**PCN# 20250730006.1**

**Qualification of RFAB using qualified Process Technology, Die Revision, Datasheet, and Assembly/Test site for select devices  
Change Notification / Sample Request**

<b>PCN Number:</b>	20250730006.1	<b>PCN Date:</b>	July 30, 2025
<b>Title:</b>	Qualification of RFAB using qualified Process Technology, Die Revision, Datasheet, and Assembly/Test site for select devices		
<b>Customer Contact:</b>	Change Management Team	<b>Dept:</b>	Quality Services
<b>Proposed 1<sup>st</sup> Ship Date:</b>	October 28, 2025	<b>Sample requests accepted until:</b>	September 28, 2025*

Sample product shipping label (not actual product label)

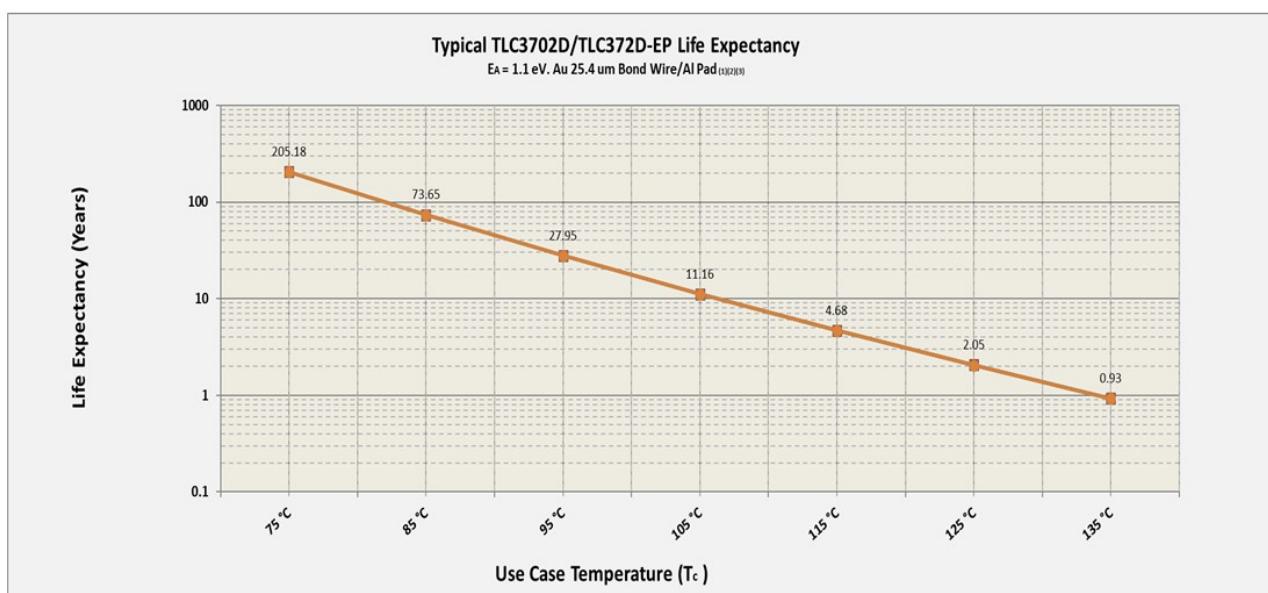
#### **Changes to product identification resulting from this PCN:**

##### **Fab Site Information:**

Chip Site	Chip Site Origin Code (20L)	Chip Site Country Code (21L)	Chip Site City
DFAB	DLN	USA	Dallas
<b>RFAB</b>	<b>RFB</b>	<b>USA</b>	<b>Richardson</b>

Die Rev [2P]	<b>Die Rev [2P]</b>
E	<b>C</b>

Current	New
Die Rev [2P]	<b>Die Rev [2P]</b>
B	<b>C</b>

Assembly Site	Assembly Site Origin (22L)	Assembly Country Code (23L)	Assembly City
FMX	MEX	MEX	Aguascalientes
<b>MLA</b>	<b>MLA</b>	<b>MYS</b>	<b>KUALA LUMPUR</b>

Assembly Site	Assembly Site Origin (22L)	Assembly Country Code (23L)	Assembly City
TAI	TAI	TWN	Taipei City
<b>MLA</b>	<b>MLA</b>	<b>MYS</b>	<b>KUALA LUMPUR</b>
